**City of Surrey
PLANNING & DEVELOPMENT REPORT**

Application No.: 7921-0018-00

PROPOSAL:

to permit the development of a 5-storey, 62-unit apartment building.

1 EAST ELEVATION
 1/16" = 1'-0"

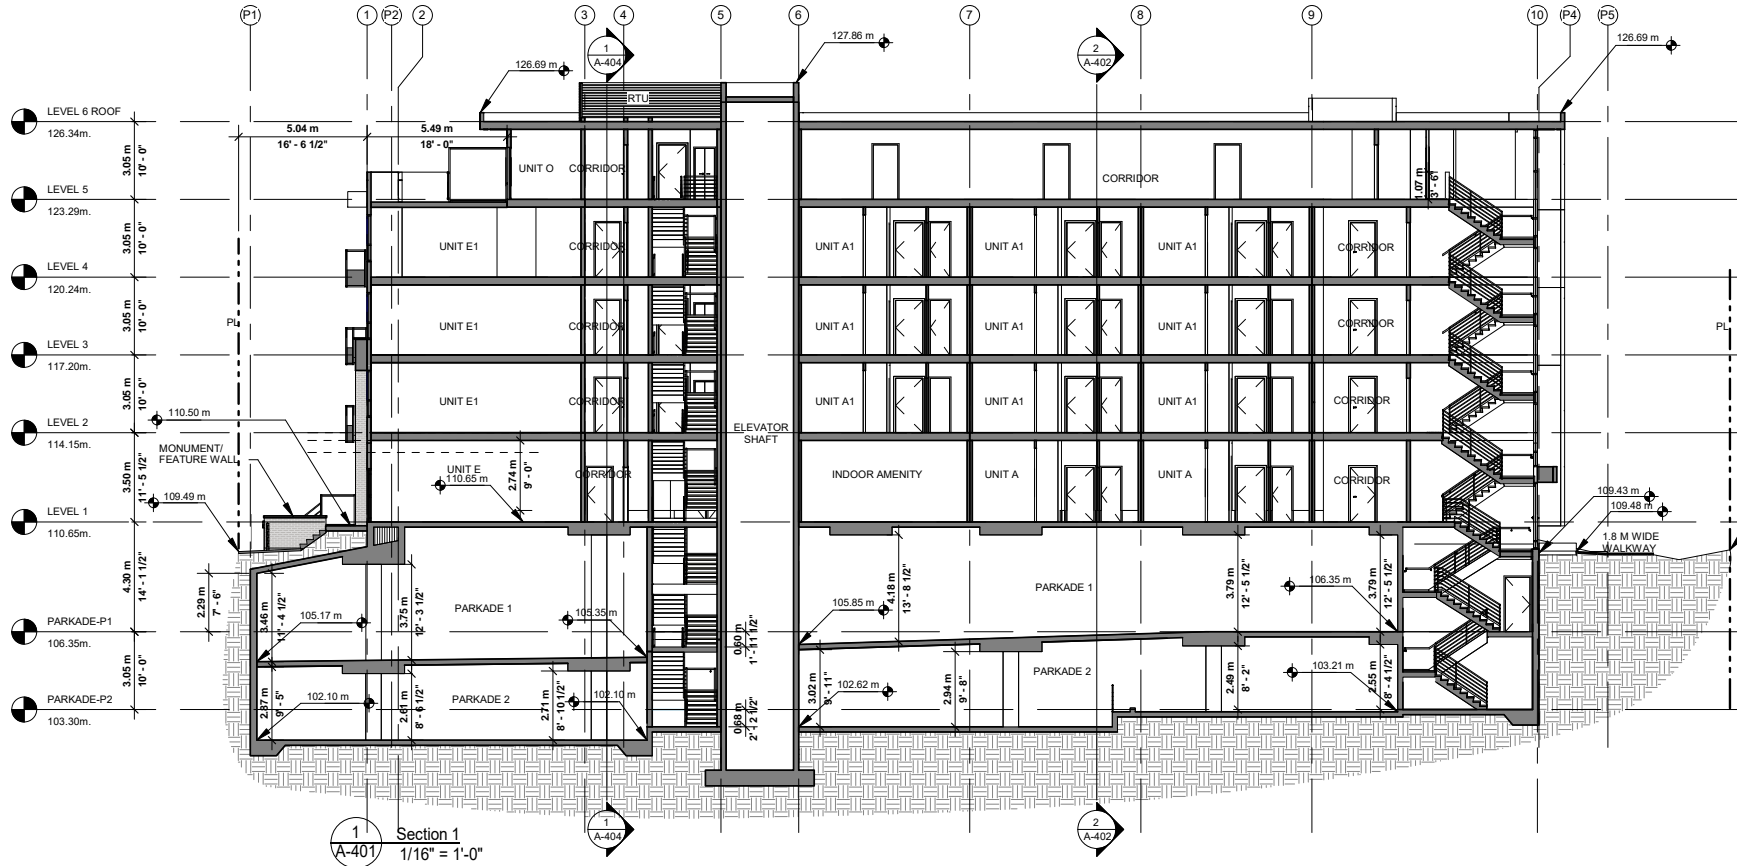
- Suggest that the building form requires simplification – reduce unnecessary elements and number of materials; consider detailing.
- Building form has been simplified, number of architectural elements have been eliminated. Only three types of the exterior finishing materials have been proposed: brick, Hardie board and Fastplank System aluminum panels. All connections and joint details between the materials are standard for the industry.

- Commend the retention of trees onsite.
 - Consider refining the exterior elevations, form, materials and colors.
- The exterior elevations have been refined, some architectural elements have been eliminated and building form simplified. Only three types of the exterior finishing materials have been proposed: brick veneer for the ground floor and porches, Hardie board for the walls and balcony soffits, and Fastplank System aluminum panels for the roof soffits and entry canopies.

1 RAMP WALL DETAIL (NEW)
1/16" = 1'-0"

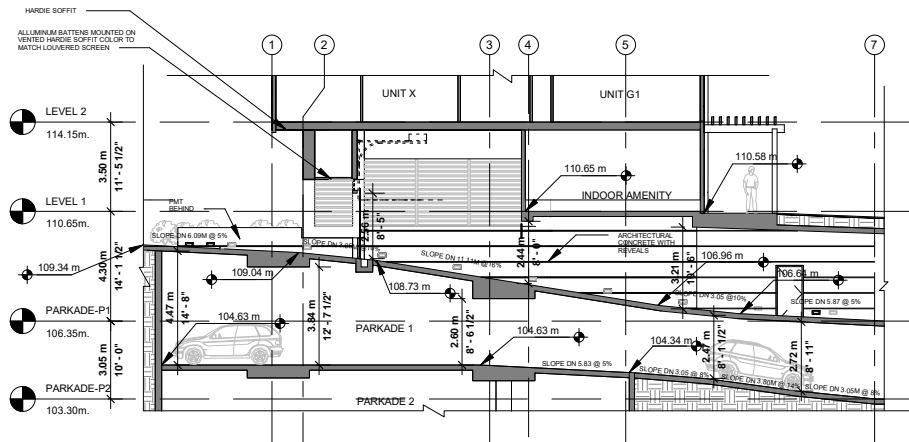
- Consider daylighting the central stairwell and provide other measures to make that stairwell attractive for residents to take the stairs.
- Proposed location of the stairwell is very common and practically standard for L-shaped buildings. Considering tightness of the site due to dedication of substantial area of the property to the retention of the trees at the south of the property, shifting stairwell towards exterior wall or provision of a deep recess with windows will significantly reduce salable area and negatively impact feasibility of the project.

- The buildable site area has been significantly reduced to provide space for the existing trees retention. Introduction of the designated bicycle ramp or bike elevator will result in more reduction of the area available for the residential units, substantial complication of building functionality and increase of the construction cost, which could negatively impact the feasibility for this type of development on such a small lot in the area of the city which is not Downtown.
